# Access Compliance Report

## Public Rights-of-Way

Intersection ID: 21514	Main Street: E_ARROWOOD_RD	Cross Street: NATIONS_FORD_RD	Location: SE
ADA ID: 473BAB812526	Ramp Type: BlendTrans2	Initial Pass/Fail: Fail	Overall Compliance: No
		Severity Score: 12.5

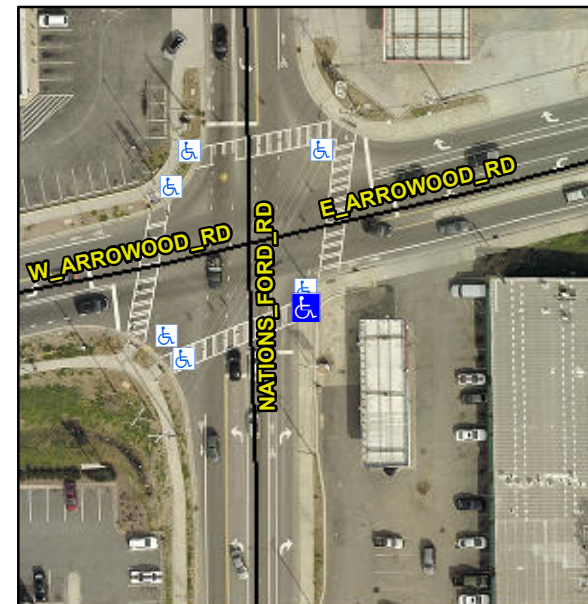
**R304.5.3**

Compliance	Description	Data	Compliance	Description	Data
N/A	Ramp Length (in)	104.0	Yes	BlendTrans Slope (%)	2.1
Yes	Ramp Width (in)	53.0	No	BlendTrans XSlope (%)	5.6
N/A	Flare Type LT	N/A	N/A	Flare Type RT	N/A
N/A	Flare Slope LT (%)	N/A	N/A	Flare Slope RT (%)	N/A
N/A	Flare Traversable LT?	N/A	N/A	Flare Traversable RT?	N/A
N/A	Landing Length (in)	N/A	N/A	DWS Provided?	N/A
N/A	Landing Width (in)	N/A	N/A	DWS Contrast?	N/A
N/A	Landing Slope (%)	N/A	N/A	DWS Length (in)	N/A
N/A	Landing X Slope (%)	N/A	N/A	DWS Full Width?	N/A
N/A	Landing Curb? (Y/N)	N/A	N/A	DWS Offset (in)	N/A
N/A	Shared Landing?	N/A			
N/A	Gutter Ponding?	N/A	N/A	Gutter Slope (%)	N/A
N/A	Gutter Lip Ht (in)	N/A	N/A	Gutter X Slope (%)	N/A
N/A	Painted X Walk1?	Yes	N/A	Painted X Walk2?	N/A
	X Walk 1 Direction	To SW		X Walk 2 Direction	N/A
	X Walk 1 Width (in)	112.0		X Walk 2 Width (in)	N/A
	X Walk 1 Slope (%)	2.9		X Walk 2 Slope (%)	N/A
	X Walk 1 X Slope (%)	0.7		X Walk 2 X Slope (%)	N/A

**Remove & Replace Curb Ramp With Two New Directional Ramps or Equivalent.**
